Public Service of New Hampshire

July 15, 1986

SBN-1157  
T.F. B7.1.2

Subject: Additional Comments on Seabrook Station Technical Specifications

FIGURE 3.4-3

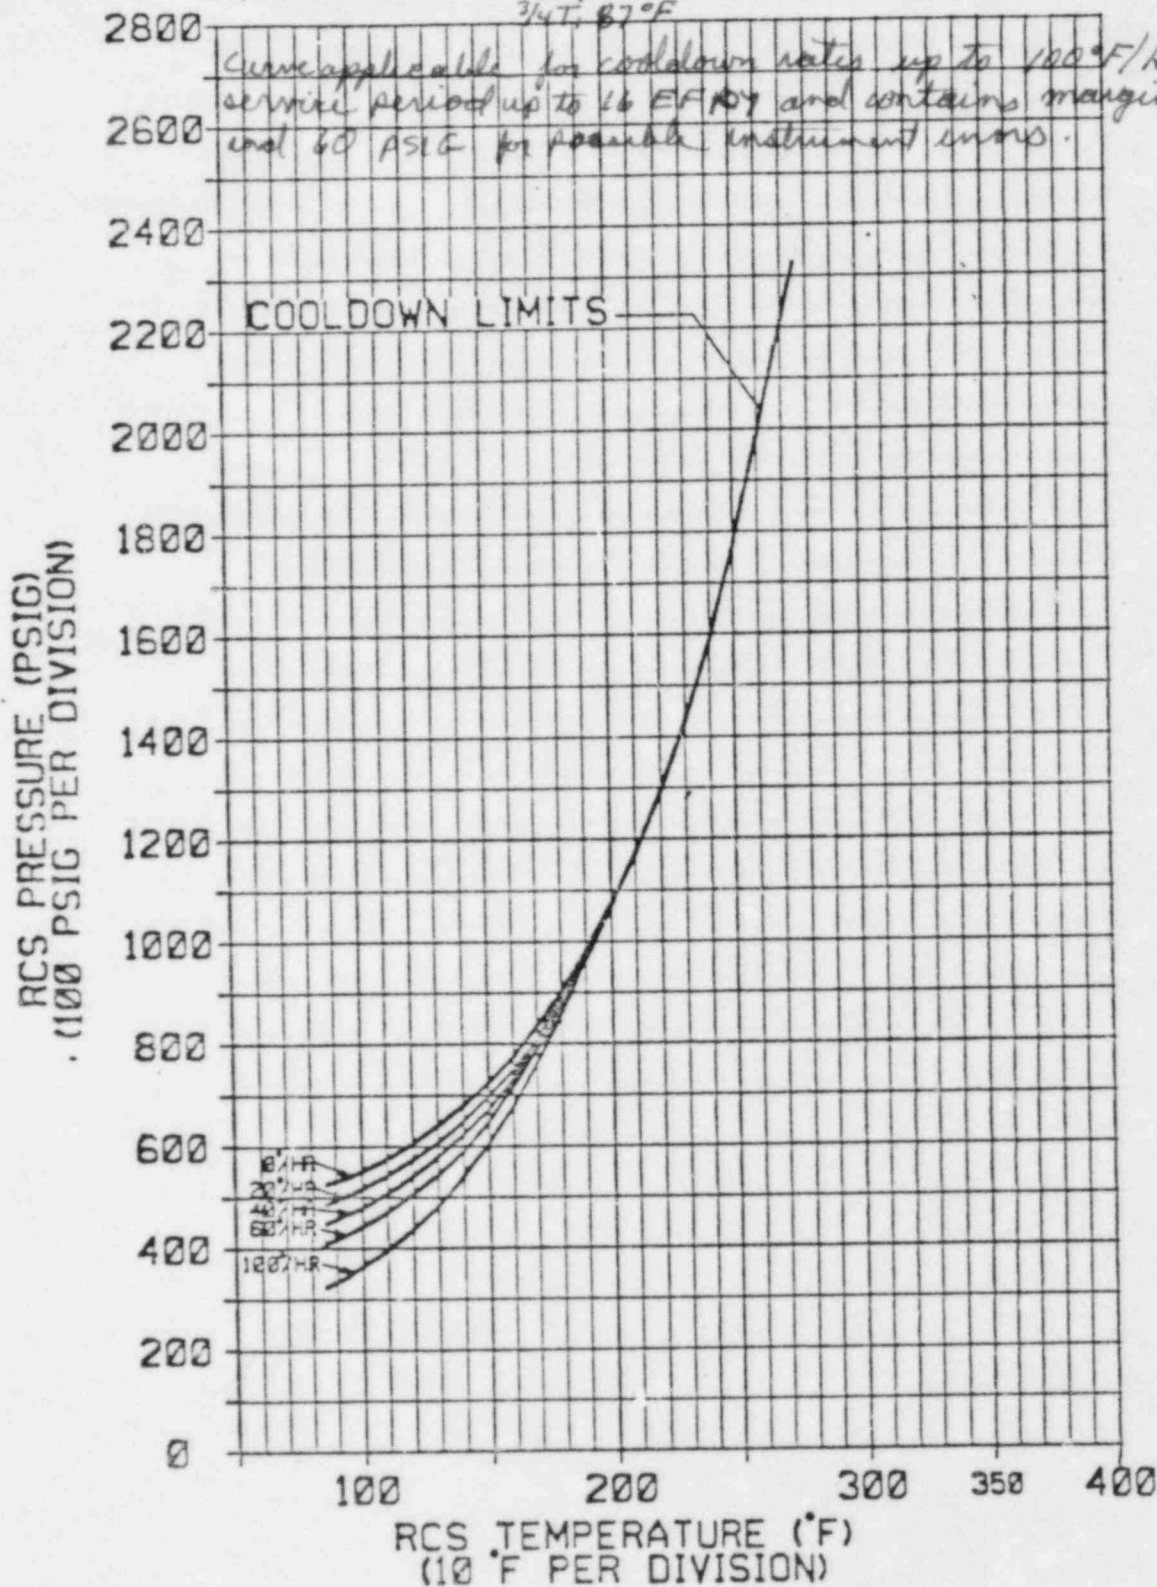
Controlling Material: Base Metal  
 Copper Content: ~~0.10~~ Conservatively assumed to be  
 RTNDT: 0.10 WT% (Actual Content = 0.06 wt%)  
 40°F  
 RTNDT after 16 EFY: 44°F, 110°F  
 3/4 T, 87°F

FIGURE 5.1-3

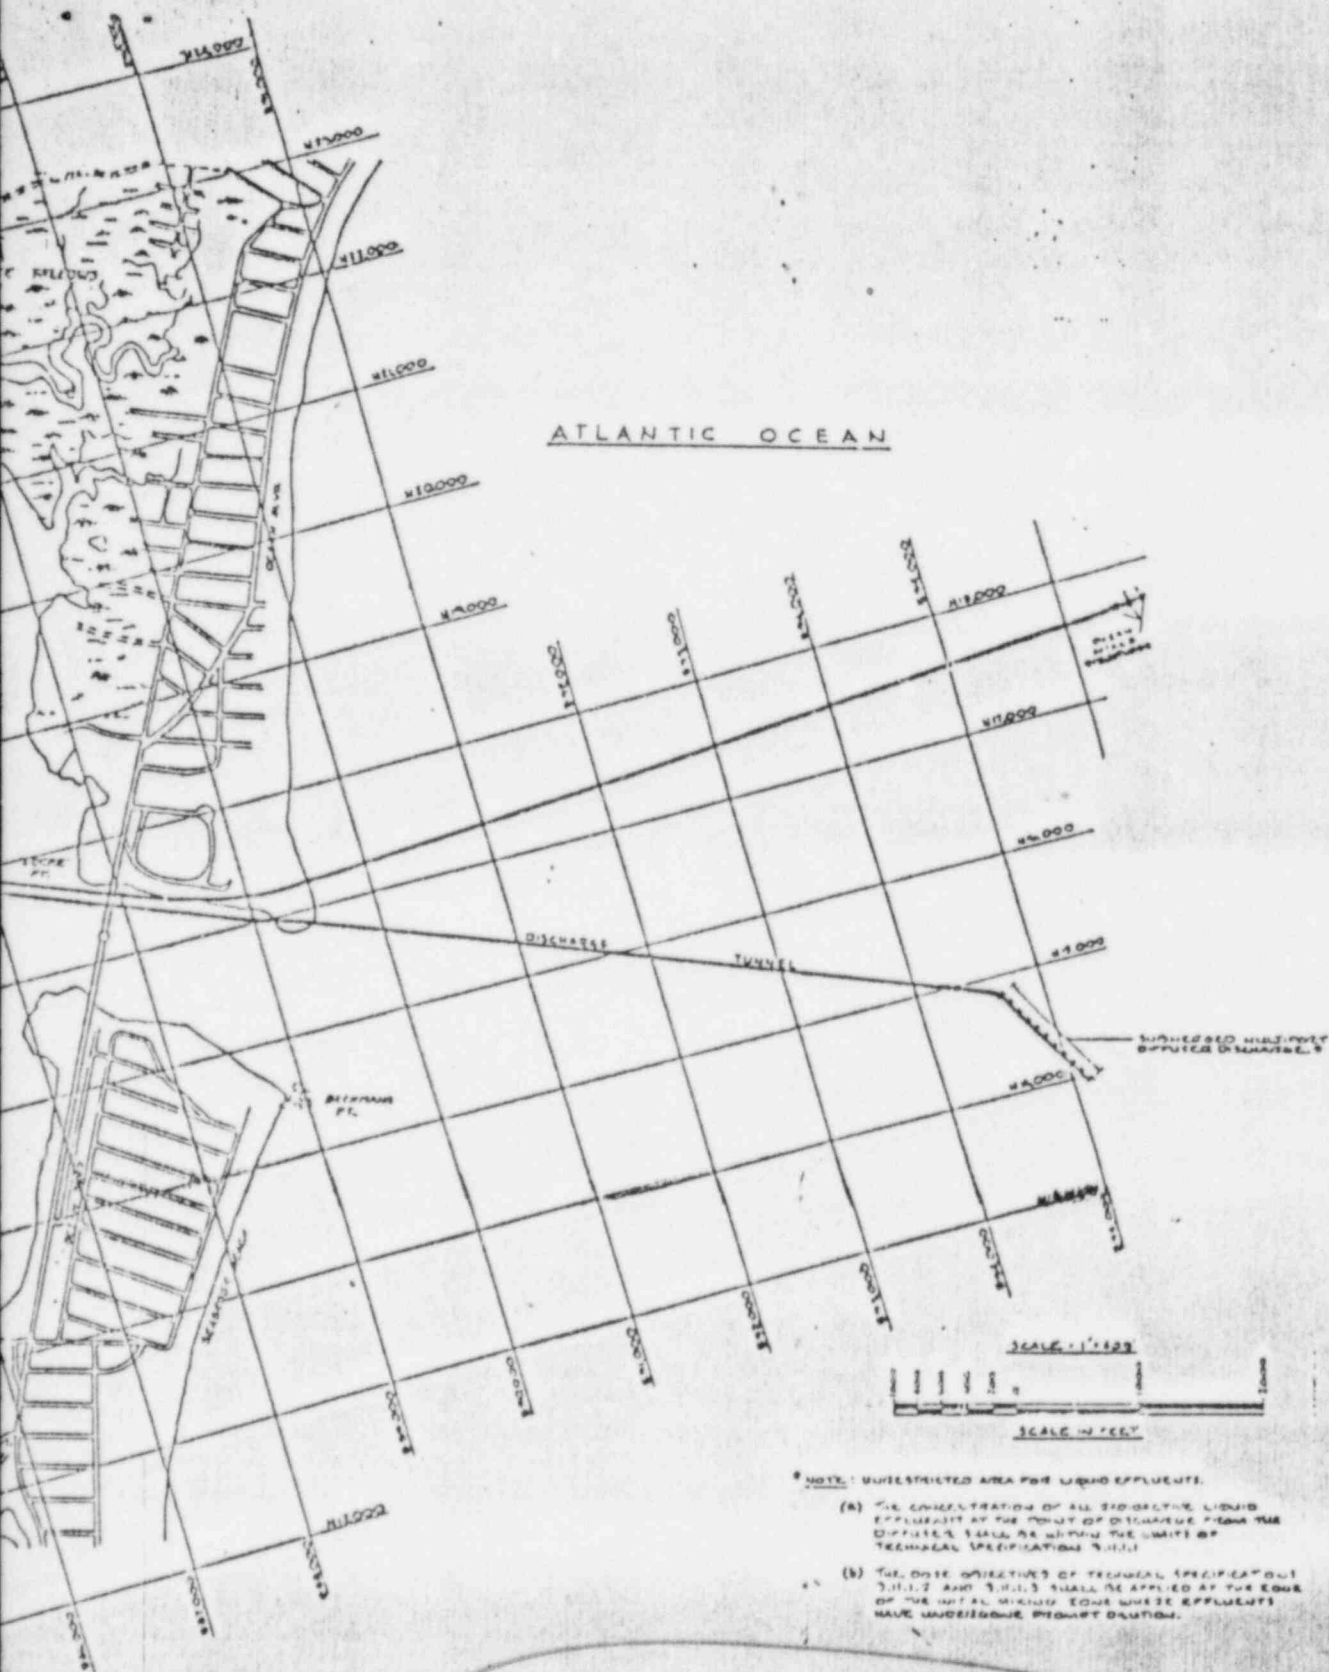
~~SITE BOUNDARY FOR LIQUID AND GASEOUS EFFLUENTS~~  
**LIQUID EFFLUENT DISCHARGE LOCATION**
